STATE OF WASHINGTON  
DEPARTMENT OF ECOLOGY

**Re: Request for construction of scale station near closed ash landfill  
Recomp of Washington Site, Cleanup Site ID (CSID) 378**

RE: Request for construction of a scale station near closed ash landfill  
Recomp of Washington Site, Cleanup Site ID (CSID) 378

Site Plan showing approximate scale location and test pits

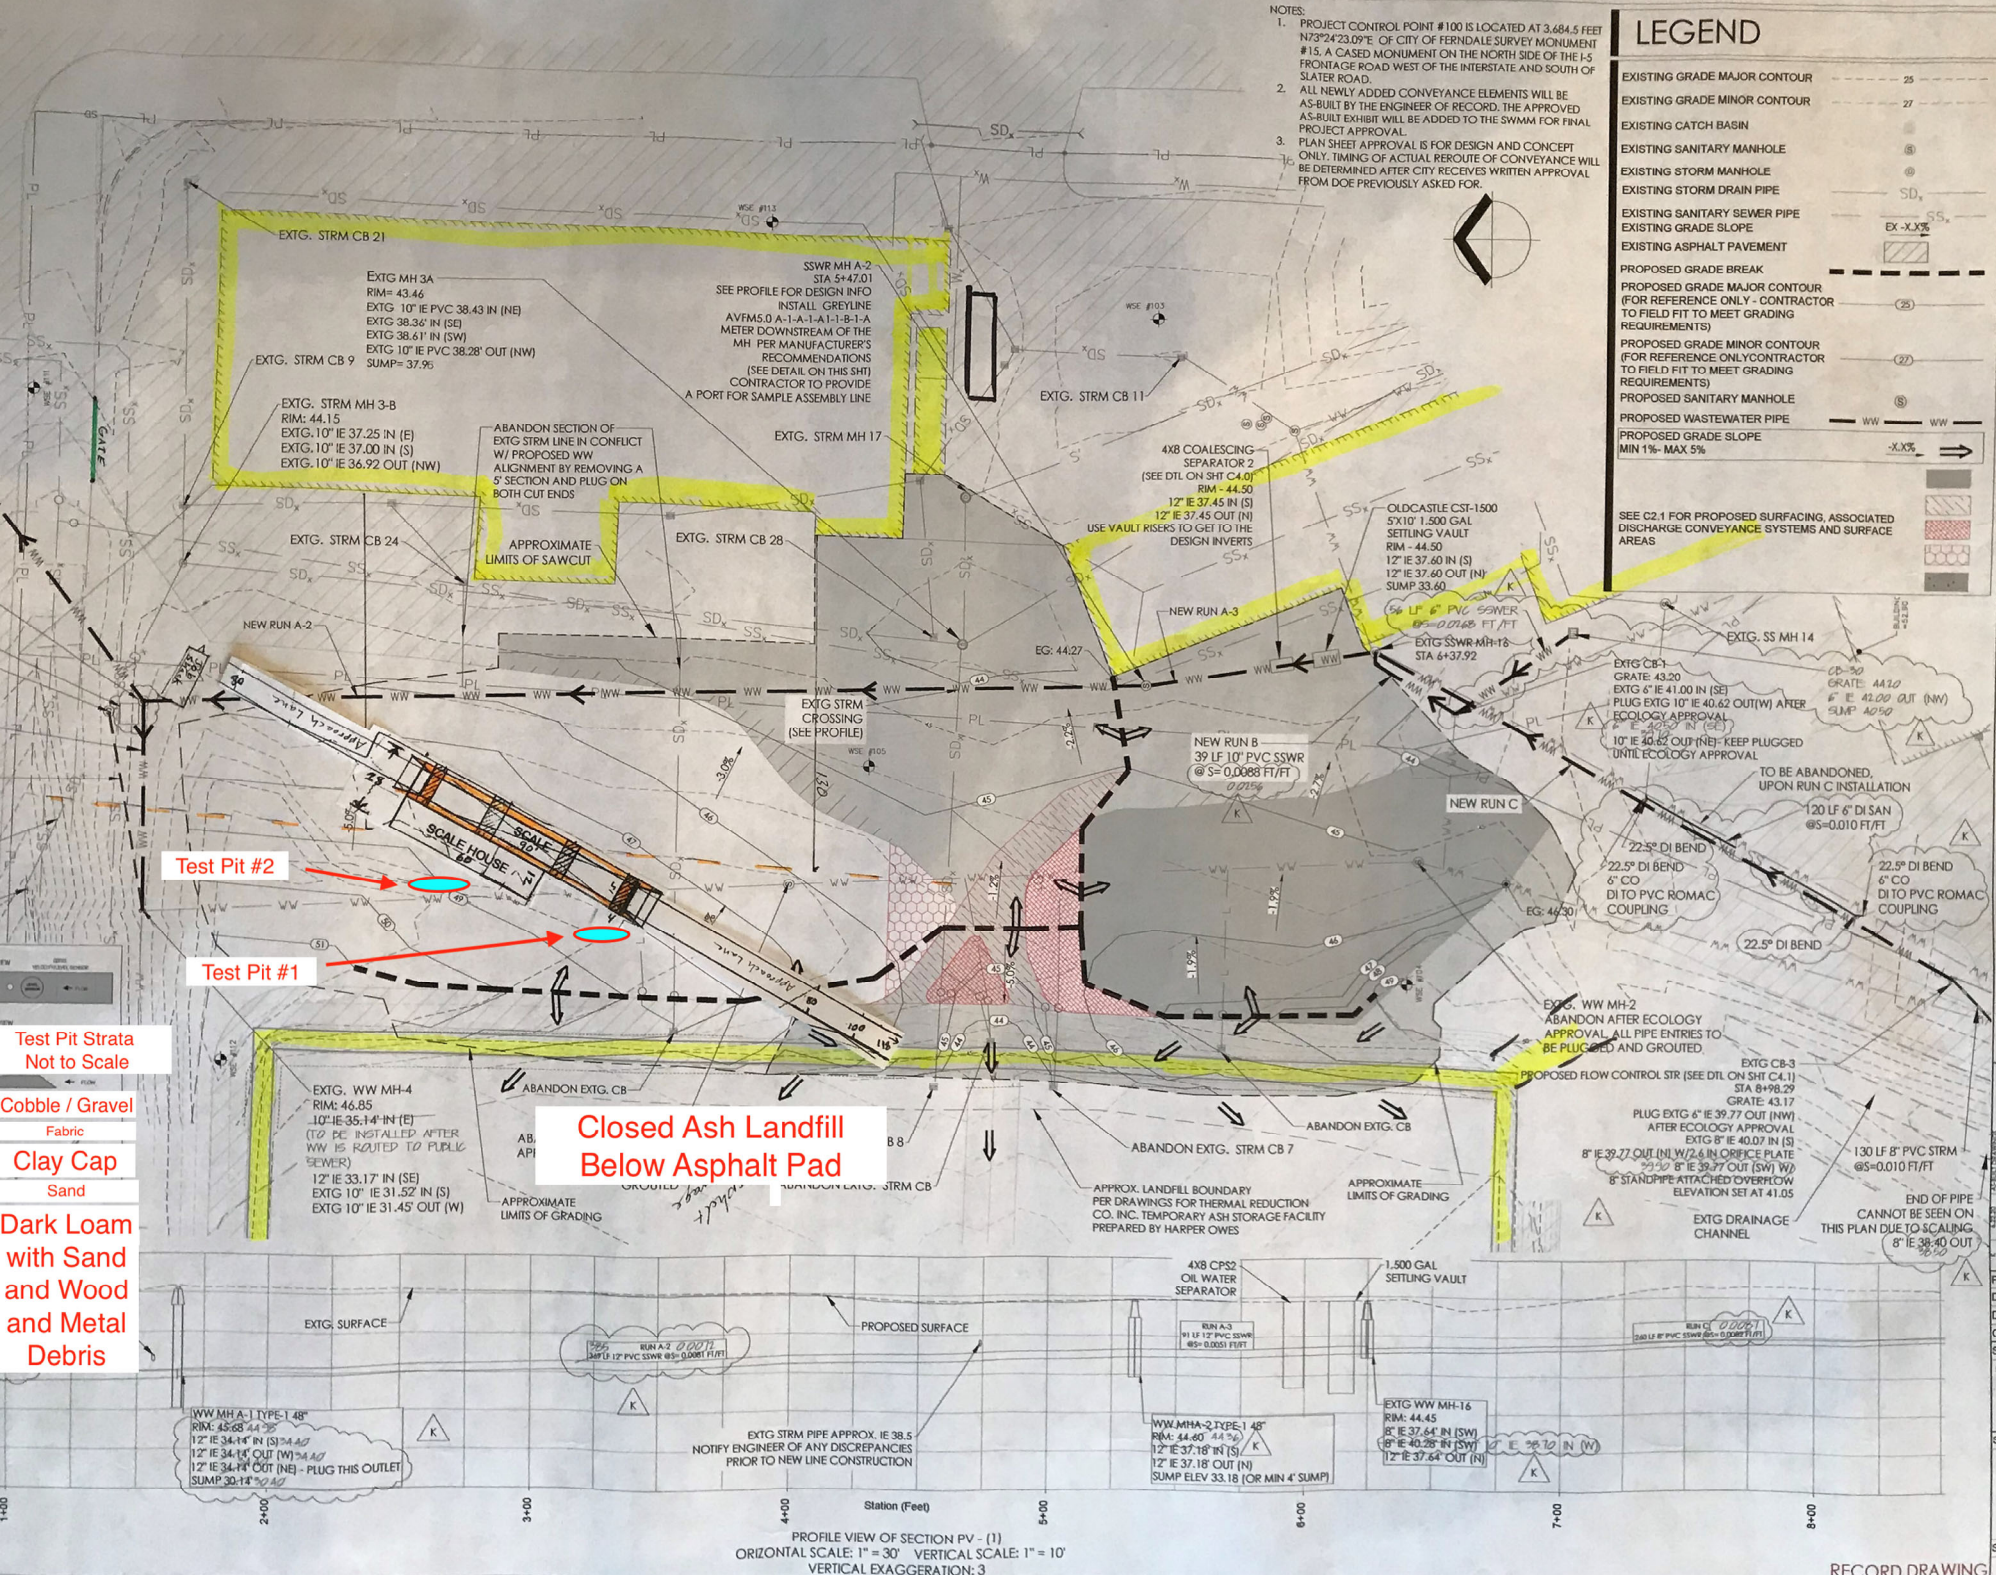
On March 4, 2021 we excavated two shallow test pits within 10'+/- of the proposed scale station to a depth of 5+ feet on the westerly side of the scale location, (side closest to the ash landfill). The test pits were to "confirm that the proposed scale is not constructed above the closed ash landfill". The finding revealed that the scale station will not be installed above the closed ash landfill although will be located above a strata that contains metal and wood debris previously identified as "demolition debris" in geological reports we have discussed.

The proposed location of scale station and the test pit locations are shown on the attached site map. The test pits indicate consistent strata across the area of interest. Both test pits showed surface cobble/gravel underlain by a filter fabric that sits atop of a clay cap layer that was placed on an imported sand layer that was placed on top of the existing surface at the time.

As stated, the scale will not be located above the ash landfill but will be above a layer that does contain sporadic wood, metal and other incidental non-putrescible debris. When viewing the attached pictures, this layer may appear to contain ash but it does not appear to be ash when visually examined nor does it have an odor or contain other items typically associated with garbage ash like; tin cans, glass or glass bottles, partially burnt paper, plastic bottles remnants and/or other burnt or decaying debris.

Ecology concurs the proposed construction of the scale is consistent with the terms of the environmental covenant. Ecology approves the proposed construction of the scale.
